SUBJECT: WOLF CREEK GENERATING STATION – STAFF ASSESSMENT OF  
RESPONSE TO 10 CFR 50.54(f) INFORMATION REQUEST – FLOOD-  
CAUSING MECHANISM REEVALUATION (CAC NO. MF3648)

STAFF ASSESSMENT BY THE OFFICE OF NUCLEAR REACTOR REGULATION

RELATED TO FLOODING HAZARD REEVALUATION REPORT

WOLF CREEK GENERATING STATION

Figure 3.2-1. Locations of Buildings, Structures, and Obstructions on the Wolf Creek Site (adapted from Figure 2-2 of the licensee's Calculation No. 14-5262-F-02).

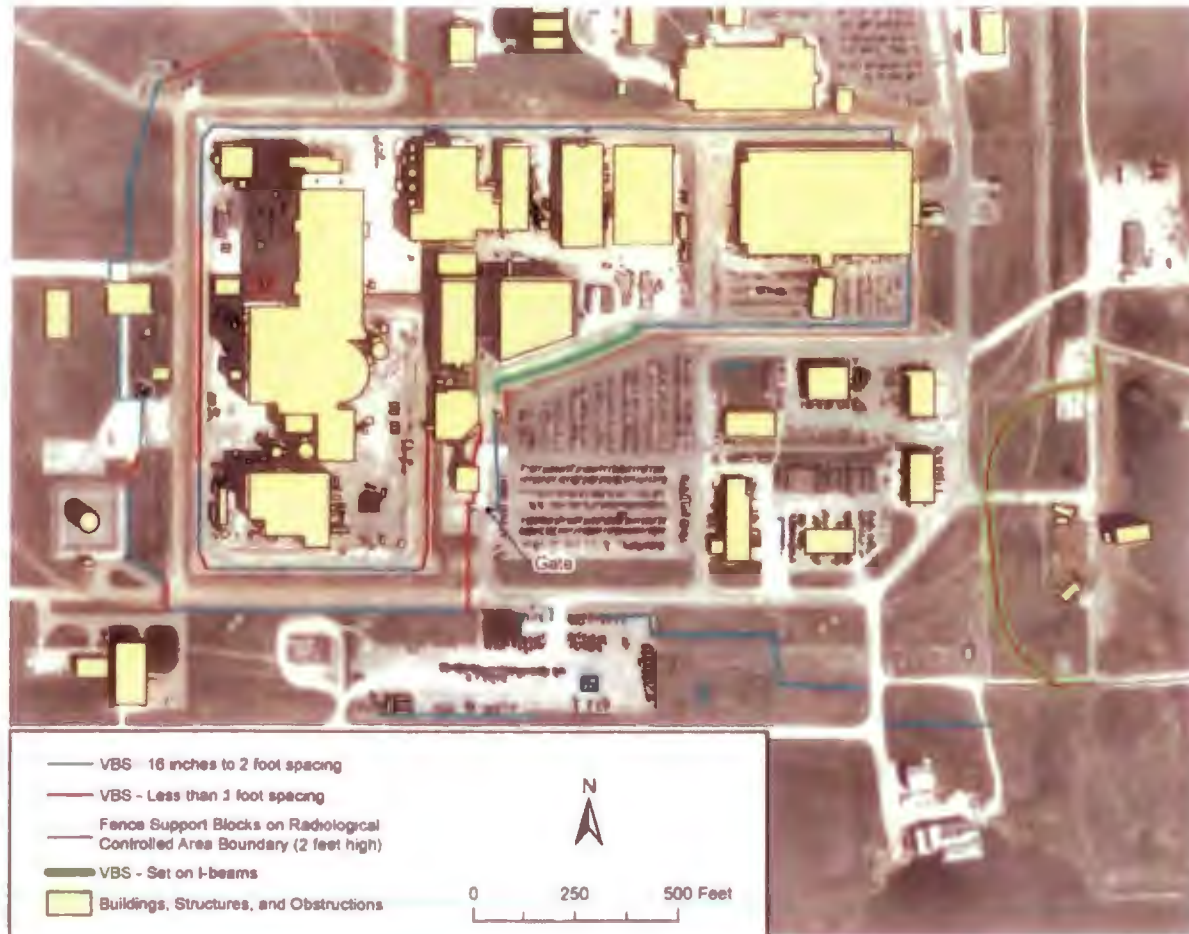
As stated in Section 3.2 of the revised Wolf Creek FHRR (WCNOC, 2015c), a two-dimensional (2D) flood-routing model, FLO-2D (Build 14.03.07), was used for the LIP flood analysis. The licensee stated that this FLO-2D Pro (FLO-2D, 2014) model represented all the topographical and manmade features (i.e., buildings, tanks, and structures) that significantly affect runoff at the Wolf Creek site (Figure 3.2-1).

Figure 3.3-2. Schematic of HEC-HMS Subbasin Connectivity of the Wolf Creek Watershed for Computation of Runoff During the PMP Event (WCNOC, 2014a, Figure 3-6).

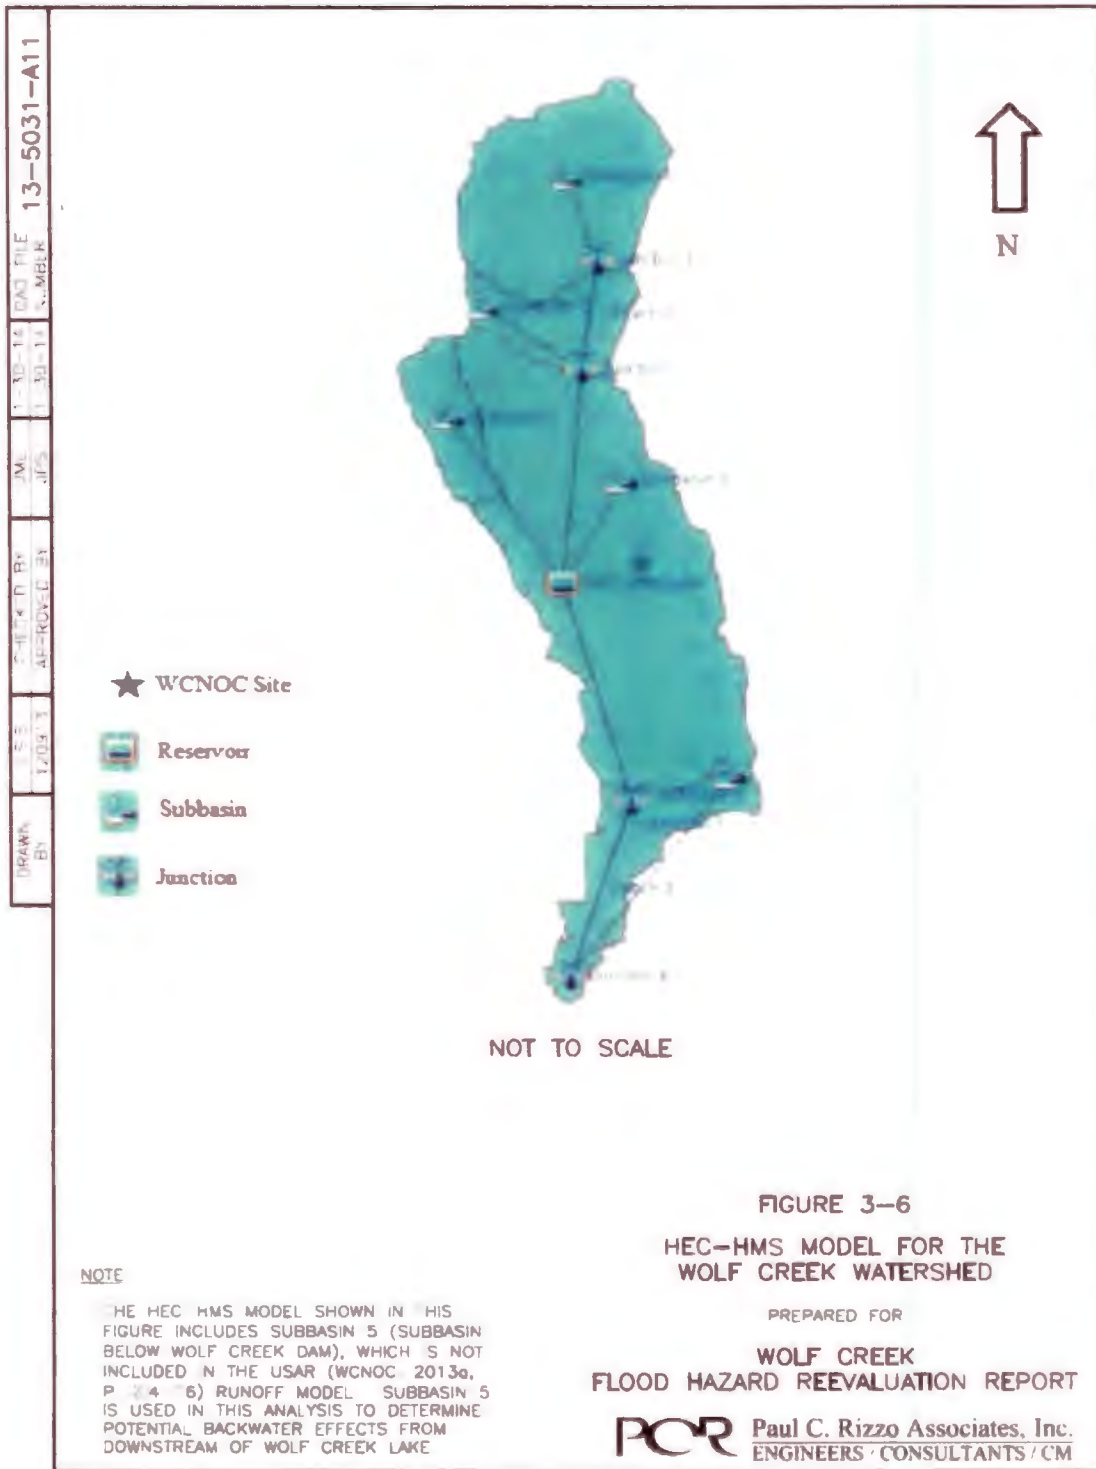
The licensee applied the HEC-HMS model to the Wolf Creek watershed (Figure 3.3-2 of this assessment) including the portion downstream of Wolf Creek Lake dam. The watershed includes five subbasins, two river reaches, and Wolf Creek Lake. The HEC-HMS model was calibrated against the 100-yr peak discharge estimated using the U.S. Geological Survey (USGS) regression equation for ungaged sites with unregulated streams, using average mean annual precipitation obtained from Figure 3 of the USGS (USGS, 2000). Because Kansas is in the Type II rainfall category for the Soil Conservation Service (SCS) rainfall distribution (SCS, 1986), the SCS Type II 100-yr/24-h rainfall depths from the NOAA Atlas 14, Volume 8, Version 2, are used as input to the HEC-HMS model as an SCS Storm. The licensee calibrated the HEC-HMS model by adjusting the curve number, lag time, and Manning's roughness coefficients.

Figure 3.3-4. Layout of Cross Sections from HEC-RAS of the Wolf Creek Watershed for Computation of Hydraulic Characteristics of the PMF event (WCNOC, 2014a, Figure 3-8)

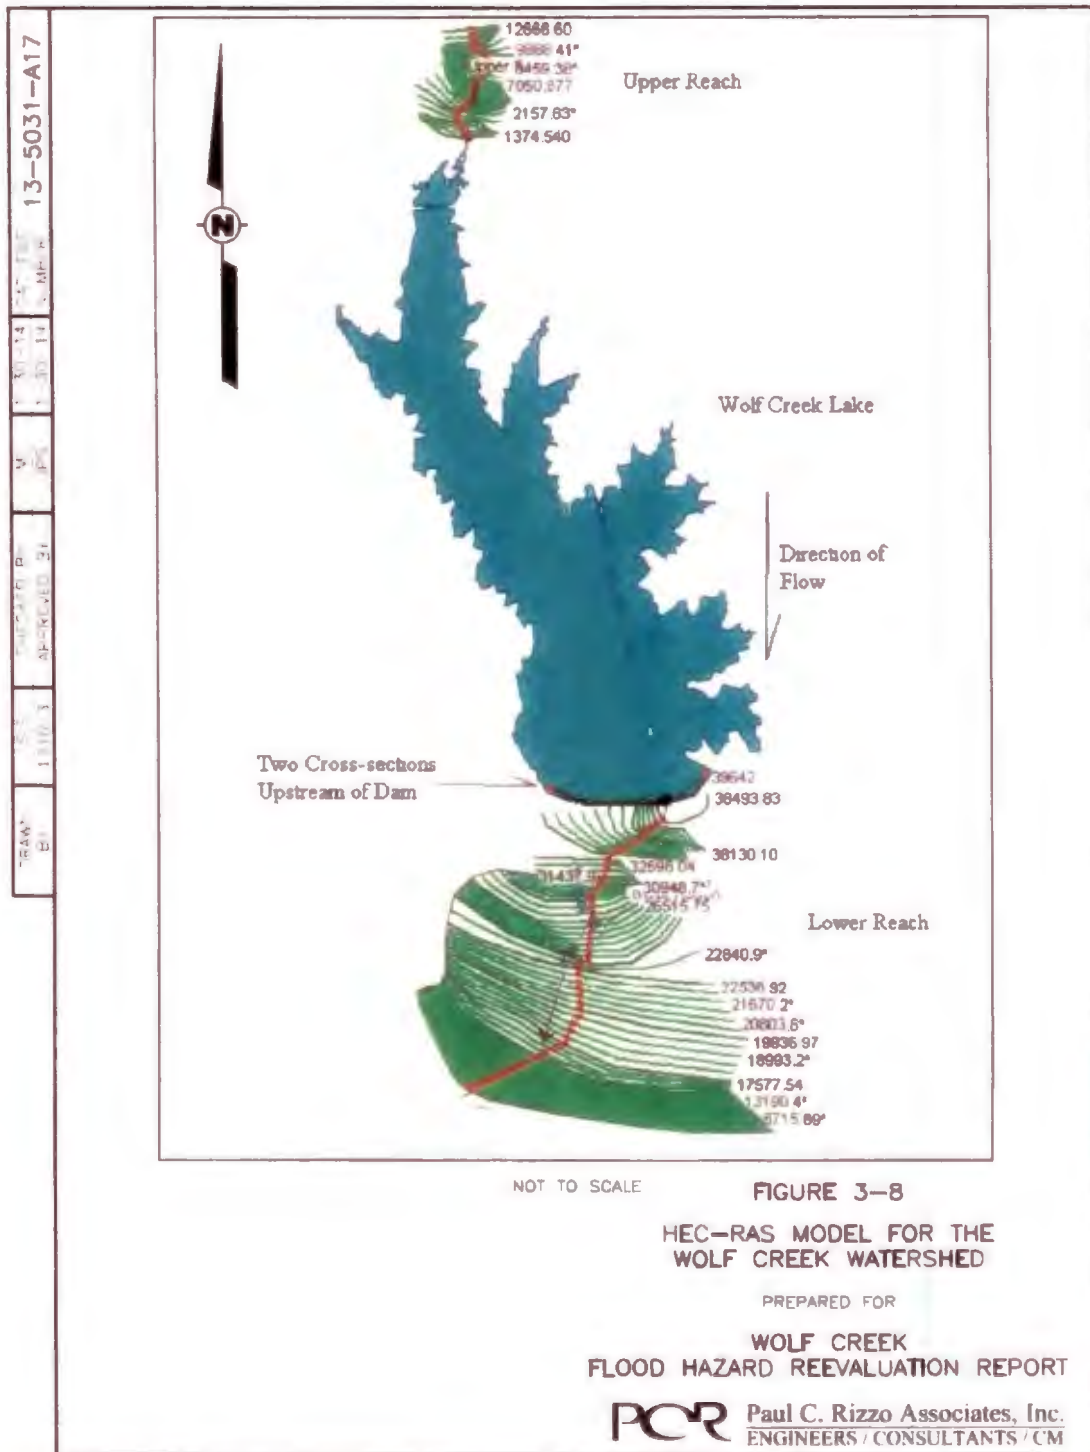
The licensee used the HEC-HMS discharges estimated for each subbasin as input to the HEC-RAS model (Figure 3.3-4 of this assessment) to produce a more refined estimate of peak water-surface elevation in Wolf Creek Lake during the PMF event and to evaluate potential effects on the flood water surface elevations in the lake if the spillway of Wolf Creek Lake Dam was partially blocked by debris. The HEC-RAS model included a reach representing Wolf Creek upstream of the lake (Upper Reach), Wolf Creek Lake, Wolf Creek Lake Dam, and a reach representing Wolf Creek downstream of the lake (i.e., Lower Reach). The licensee stated that HEC-RAS was calibrated by adjusting the Wolf Creek Dam weir coefficients against water level above the crest elevation obtained from the existing spillway rating curve for Wolf Creek Lake.

Figure 3.3-5. Fetch Determination in Wolf Creek Lake for Computation of Wind Wave Activity for the PMF Event (WCNOC, 2014a, Figure 3-8).

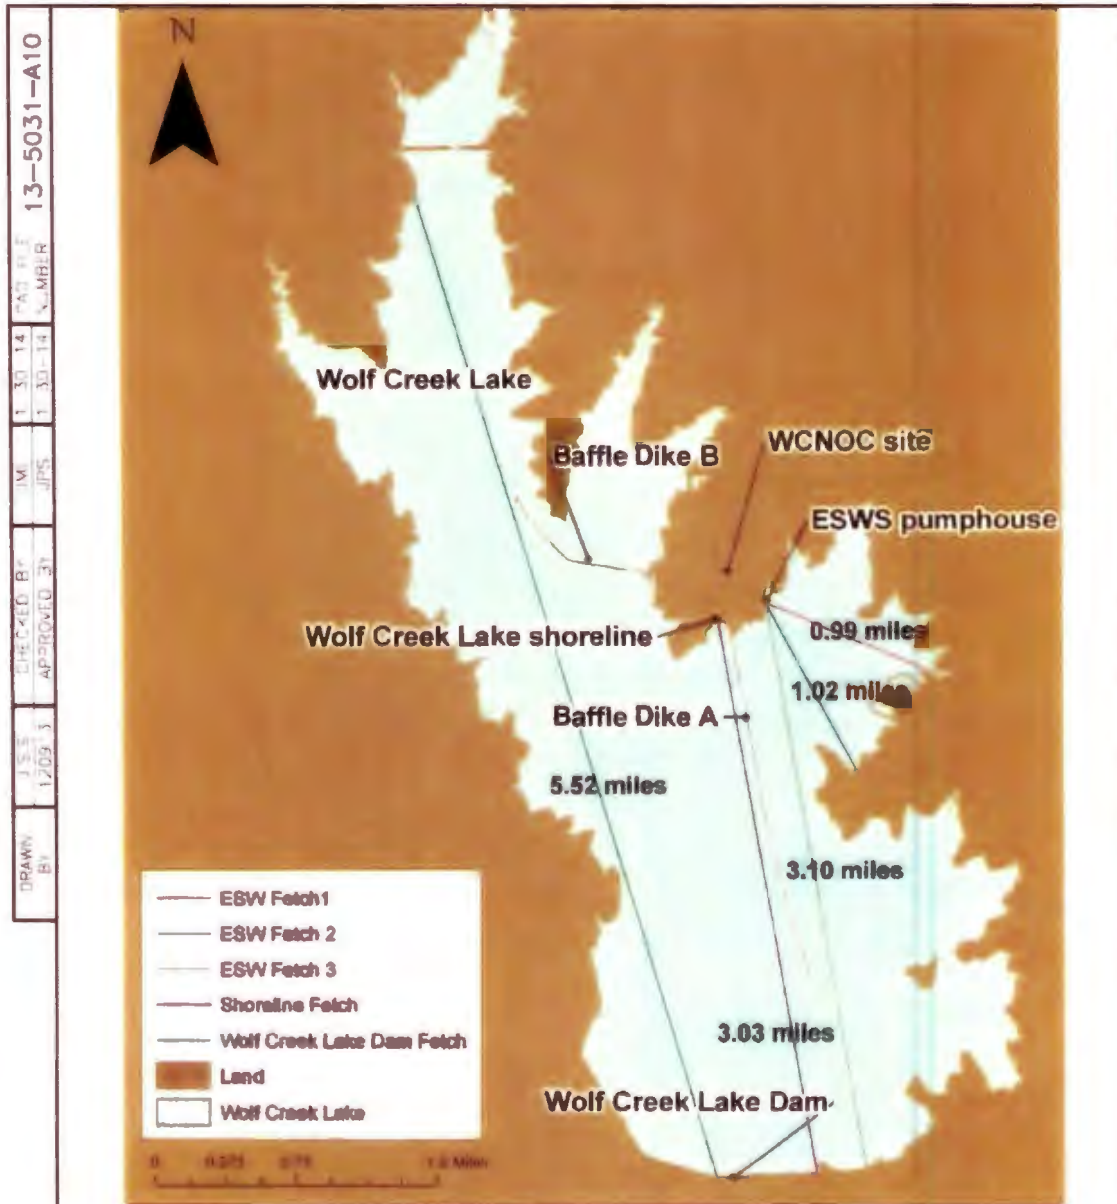
The licensee also evaluated wind waves and runoff coincident with the PMF at Wolf Creek Lake Dam, the Wolf Creek Lake shoreline, and intake structure of the ESWS Pumphouse (Figure 3.3-5 of this assessment). The licensee used the peak PMF water surface elevation obtained from HEC-RAS Case 6 as the stillwater surface elevation for wind wave estimation. The licensee estimated the wind wave effects to be 7.0 ft., 0.8 ft., and 4.9 ft. at the Wolf Creek Lake Dam, Wolf Creek Lake shoreline, and the ESWS Pumphouse, respectively. The combined maximum flood water surface elevations were 1,100.6, 1,094.4, and 1,098.4 ft. MSL at the three locations, respectively. The NRC staff consider that the licensee's approach is consistent with present-day methods.

Figure 3.4-1. Locations of Dams Upstream of the Wolf Creek Site on the Neosho River Identified by the Licensee (WCNOC, 2014a, Figure 3-12)

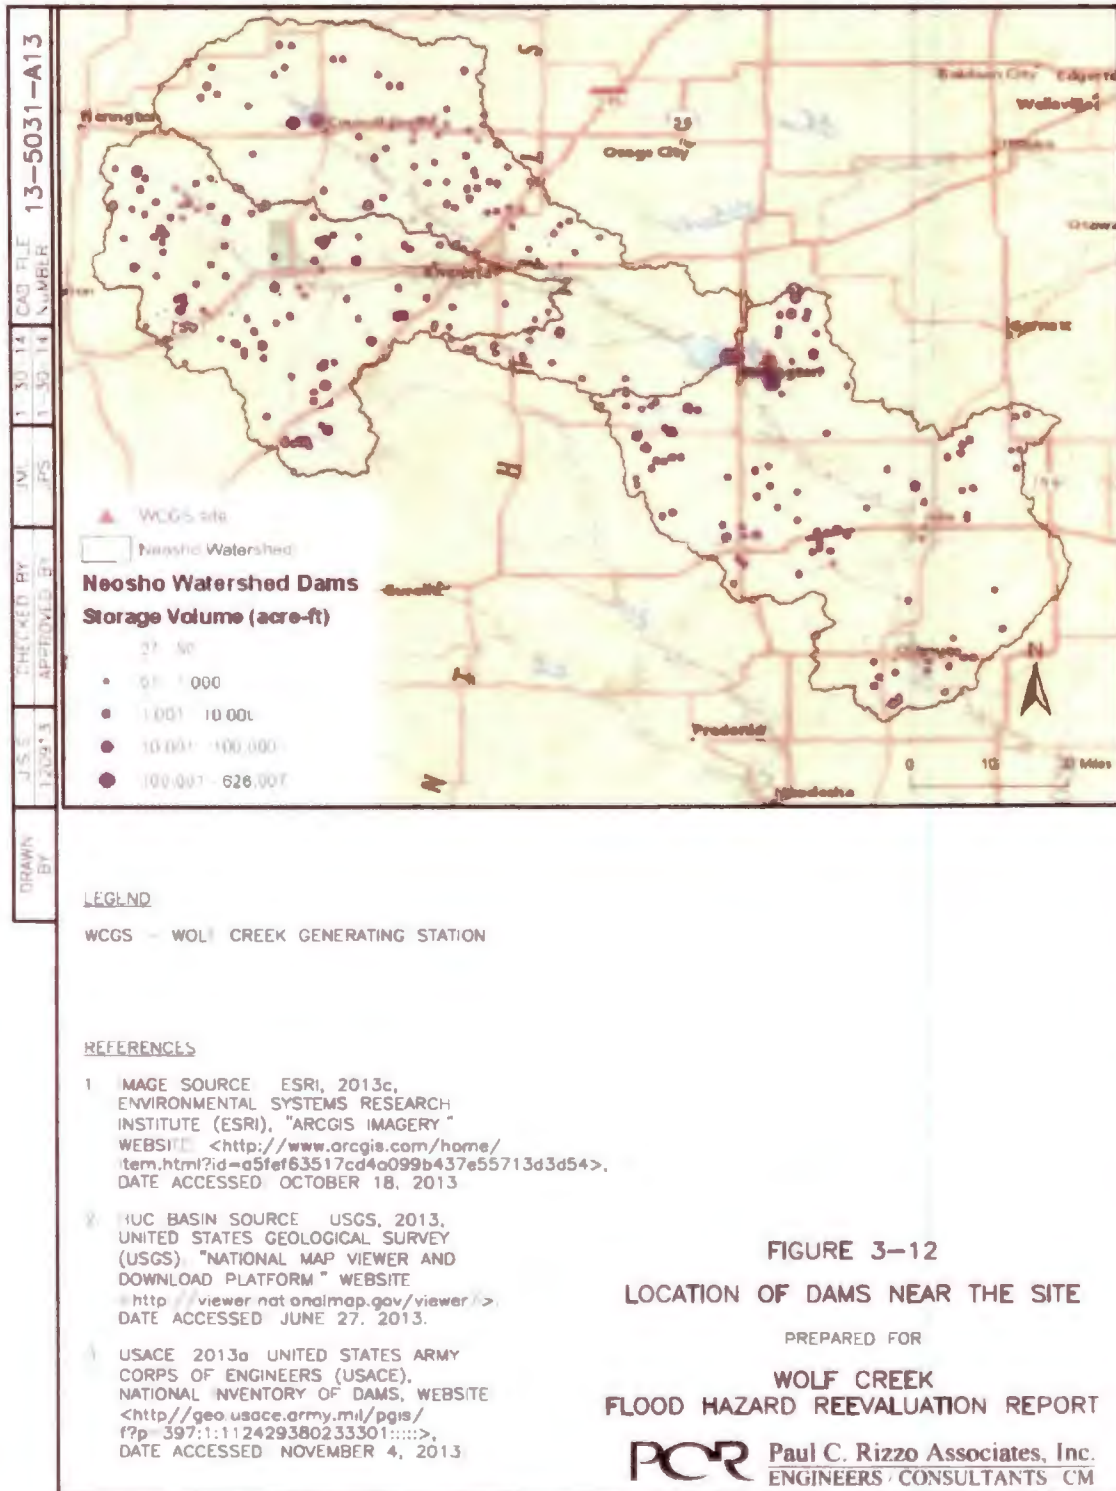
The licensee stated in its FHRR (WCNOC, 2015c) that except for the Wolf Creek Lake Dam, no other dams were listed in the USACE National Inventory of Dams (NID) database for the Wolf Creek watershed. However, 322 dams are located within the Neosho River watershed adjoining the Wolf Creek watershed (Figure 3.4-1 of this assessment). The licensee's assessment included the following steps:
